Re: New York Methodist Hospital
Center for Community Health
505-525 6th Street (Block 1084,
Lots 25, 26, 28, 39-44, 46, 48,
50-59, 164, 1001, and 1002)
BSA Cal. No. 289-13-BZ

We are submitting this letter in connection with the application by New York Methodist Hospital ("NYM" or the "Hospital") for a variance to facilitate the development of a new ambulatory care facility (the "Center") Hospital's main campus in Brooklyn. This letter and the attached materials provide responses to questions asked by the Board at the February 11, 2014, public hearing on the application, as set forth below.

Garage Overbuild Study
ILLUSTRATIVE. FOR INFORMATION ONLY

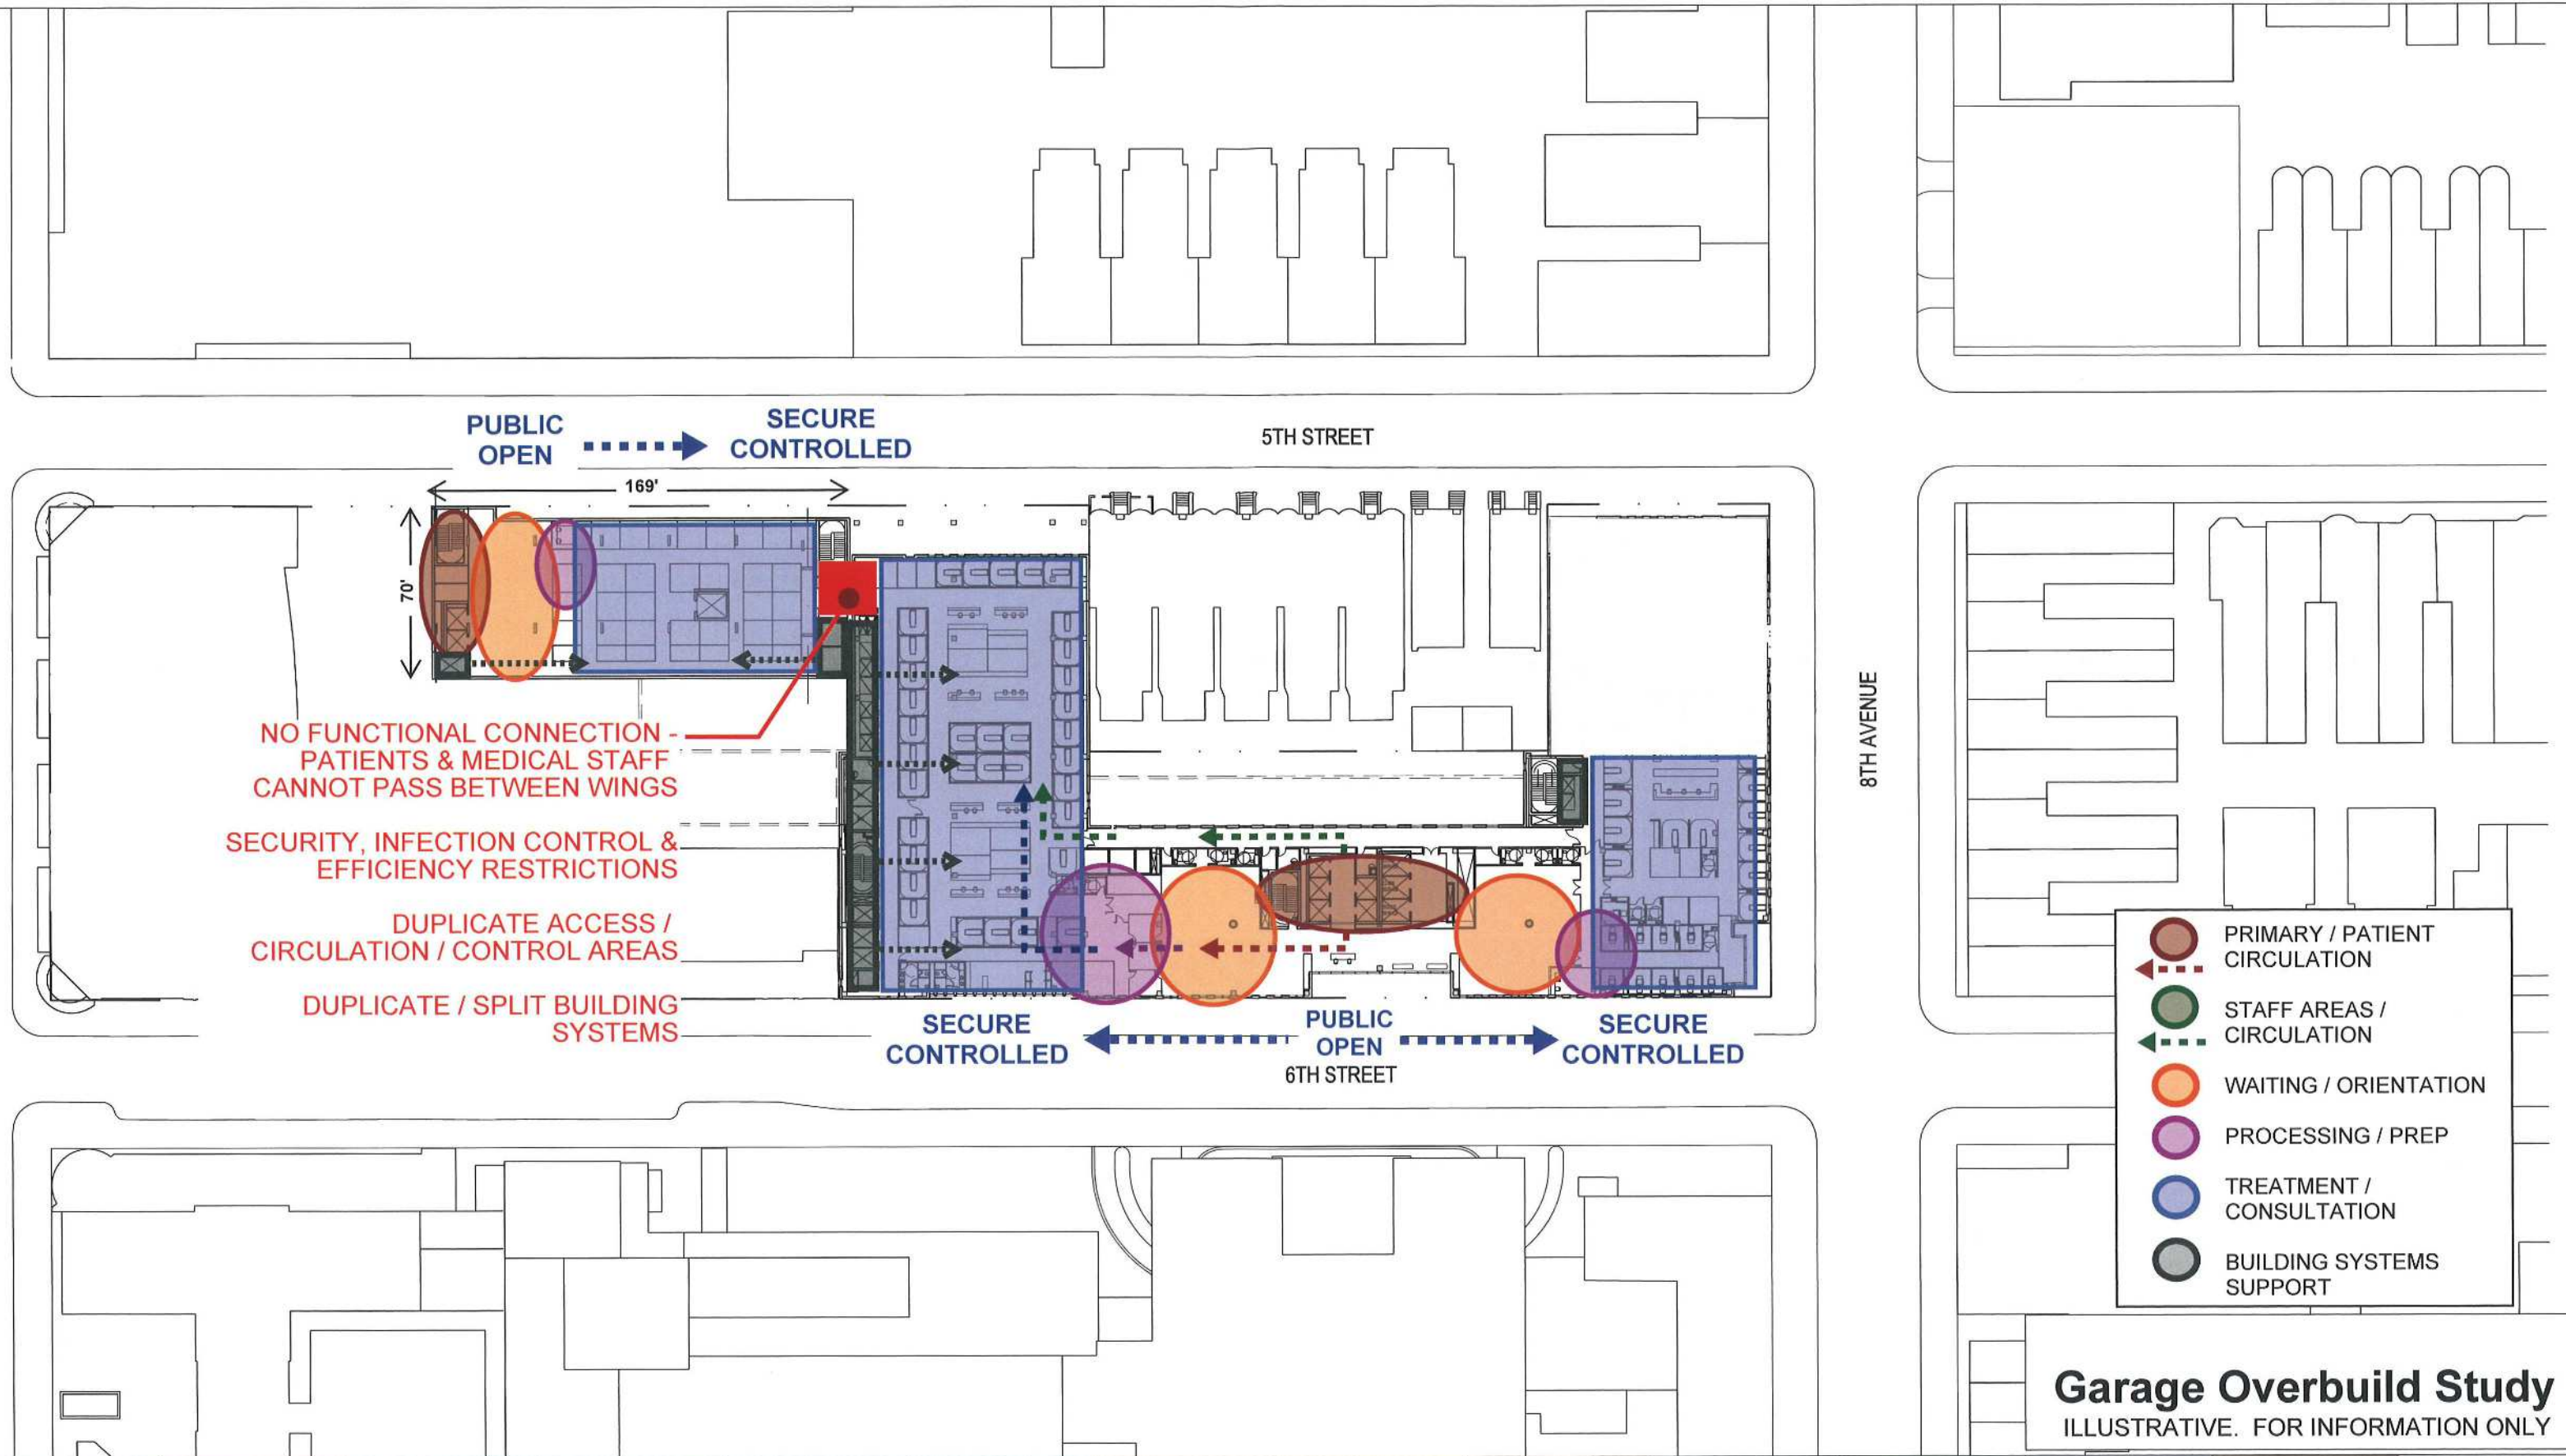
2. *Provide diagrams illustrating the programmatic issues associated with construction a larger portion of the Center, e.g. up to five stories, over the existing Hospital garage.*

An additional wing located over the existing Hospital garage, with a height of five stories (or more or less), would not satisfy the Center's programmatic needs because the geometry would necessitate that it be functionally and operationally segregated from the remaining portion of the building. Connections could not be made between the garage wing and the main building because (i) the vehicular driveway and loading area would separate the garage wing and the rest of the building on the ground floor (see Ground Floor Plan Diagram) and (ii) security, infection-control, and operational standards for the ambulatory surgery facilities would prohibit pass-through access to the garage wing on the 2nd through 4th floors, which house CSS, PACU, and the ORs (see 2nd Floor Plan through 4th Floor Plan Diagrams). A connection would be possible only at the 5th floor, and even then would create a very long, inefficient circulation network between the main portion of the new facility and the garage wing of the building—a circulation network which would run through departments rather than distribute to them efficiently from a central core. In addition, the program areas within the garage wing and western wing on the 5th floor would have no functional relationship to each other, and therefore any connection between them would be detrimental to such programs and introduce security, infection, and efficiency concerns. (See 5th Floor Plan Diagram)

Such a design would also require an additional vehicular drop-off and pedestrian entrance on 5th Street, since almost all of the garage wing's floors, including the ground floor, could not be accessed from the building's central circulation core on 6th Street. This configuration would require an inefficient utilization of space, with more area dedicated to vertical and horizontal circulation and vehicular access, and would result in increased vehicular traffic on 5th Street. (See Ground Floor Plan Diagram) In short, the building would have the same deficiencies as the Complying Development. To the extent that the garage wing complied with applicable height and setback and rear yard equivalent regulations, it would similarly contain very narrow floor plates, capable of accommodating only inefficiently small suites for the Hospital's clinical institutes.

The attached Garage Overbuild Study demonstrates the programmatic deficiencies of a development that includes construction over the existing Hospital garage. The proposed design configuration of the Center on the U-shaped development site is based on a design principle by which two distinct circulation paths are provided (i) for patients and (ii) for staff, oriented around a centrally located core, with patients led progressively toward more controlled, private, and dedicated spaces—from the waiting area to registration, then to processing, then to preparation, and finally to treatment in the eastern and western wings of the building. This design not only provides a rational, efficient circulation network, but it is also needed to accommodate certain ambulatory care facilities in the building. The surgical suite, for example, must be located in the Center's western wing because the central core area and eastern wing do not have sufficient dimensions to accommodate the facilities. The PACU unit and CSS, which must be adjacent to the surgical suite, are therefore also located in the western wing, on the floors immediately above and below.

MASSING COMPARISON

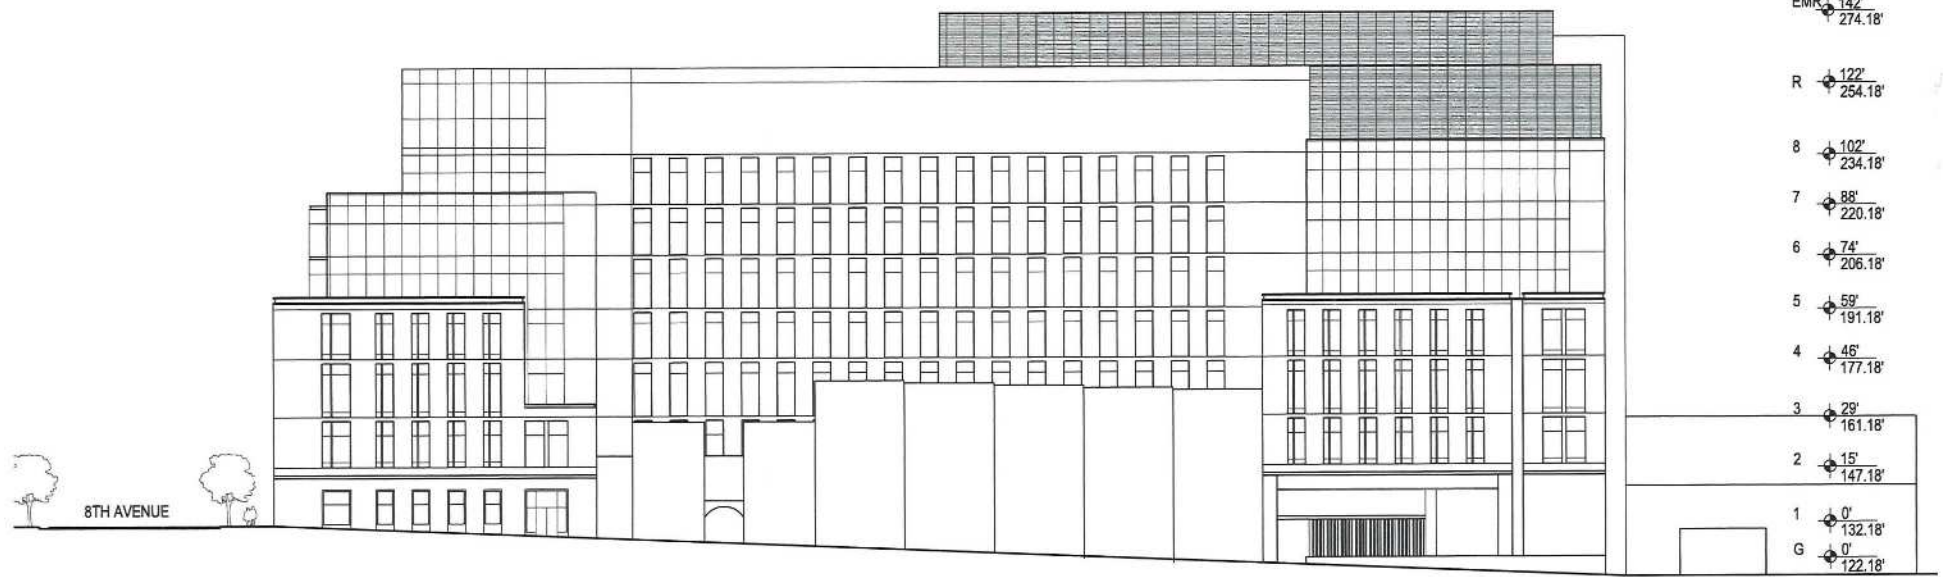
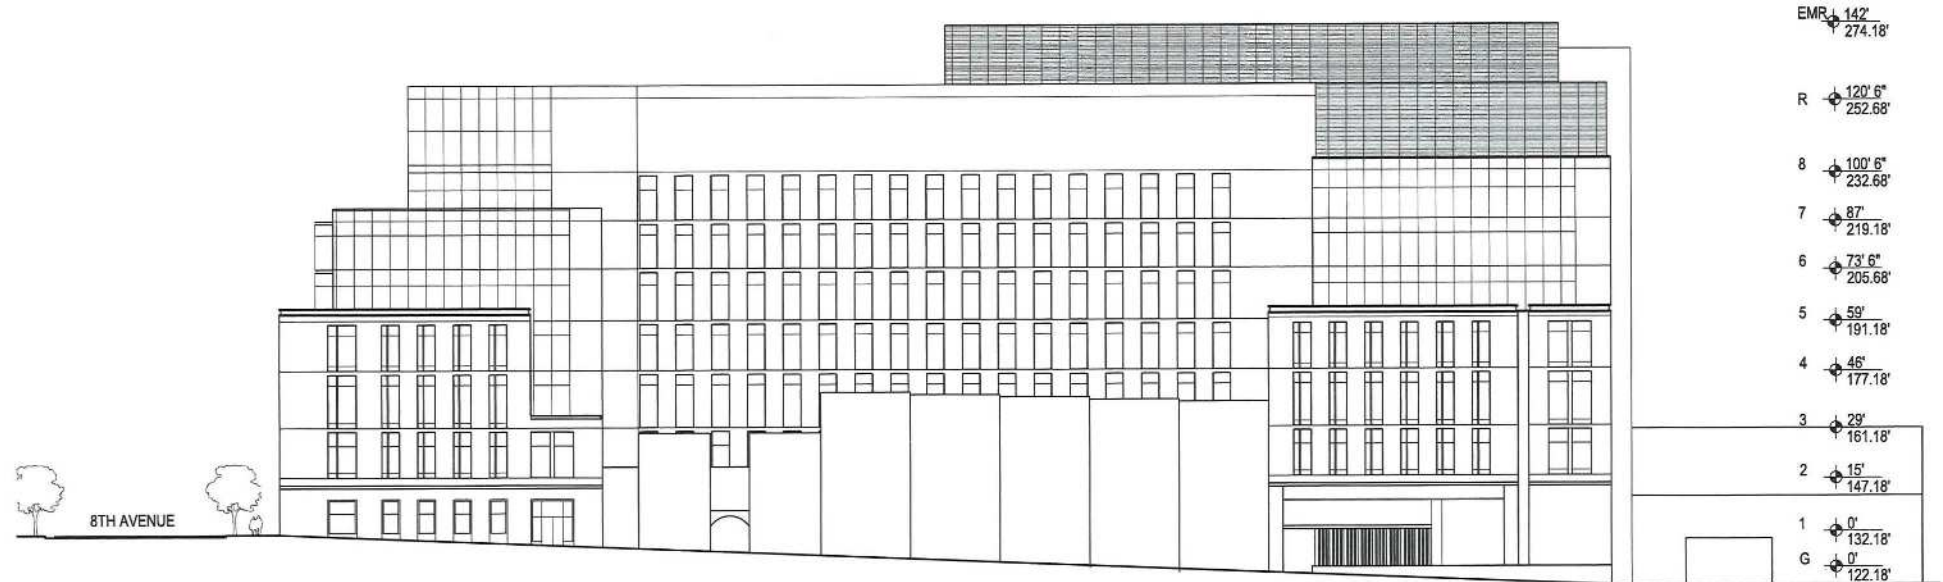
3. *Explain why the proposed floor-to-floor heights of the Center, particularly those for the 6th and 7th floors, are needed.*

Perkins Eastman Architects studied an alternate design for the Center in which the 5th through 7th floors are each reduced in floor-to-floor height by 6 inches to reduce the total building height by 1'-6". As shown by the attached elevation comparison

and massing comparison, these modifications result in a negligible reduction in the building's apparent height, while reducing the building's planning flexibility. They also compromise the efficiency of the building in a number of ways:

The floor-to-floor height of most of the proposed Center's floors is 14'-0", which is appropriate for accommodating the medical facilities and equipment that the Center may need now or in the future. The consistency of this height among the building's floors provides appropriate flexibility for the reprogramming of the building.
